Product Change Notice (PCN)

PCN Number: PCN-0456242R-02

Product(s) Affected: *SJ1-353XNS Series (SJ1-3533NS, SJ1-3534NS, SJ1-3535NS)*

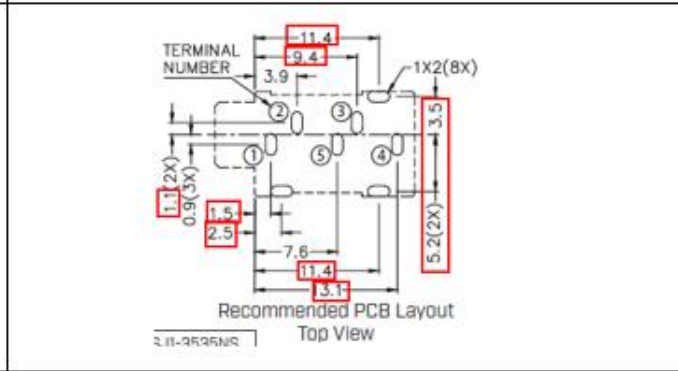
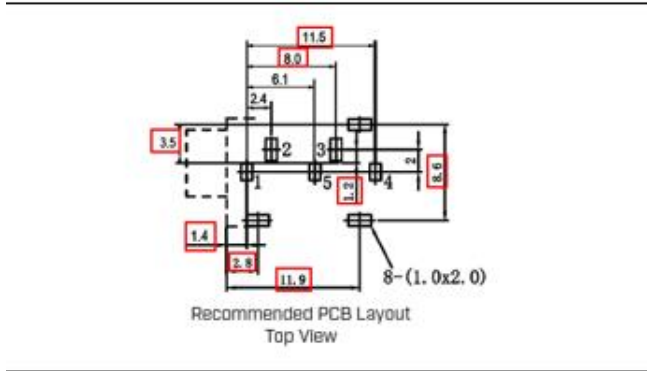
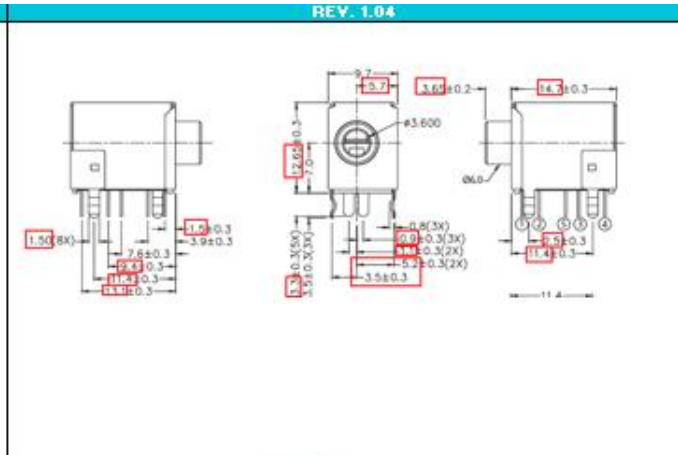
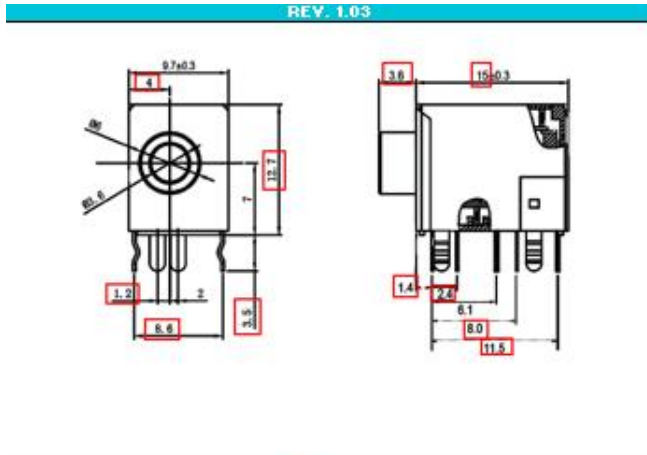
Description of Change: *Minor Layout and Material Difference. See image Below*

DESCRIPTION	MATERIAL	PLATING/COLOR
terminal 1	brass	silver
terminal 2	phosphor bronze	silver
terminal 3	phosphor bronze	silver
terminal 4	brass	silver
terminal 5	brass	silver
spring	stainless steel	nickel
bushing	brass H59	nickel
shield	SPCC t=0.30	nickel
housing	PBT (UL94V-0)	black

DESCRIPTION	MATERIAL	PLATING/COLOR
terminal 1	brass	tin
terminal 2	brass	tin
terminal 3	brass	tin
terminal 4	brass	tin
terminal 5	brass	tin
spring	stainless steel	
bushing	brass	nickel
shield	cold rolled steel	nickel
housing	PBT (UL94V-0)	black
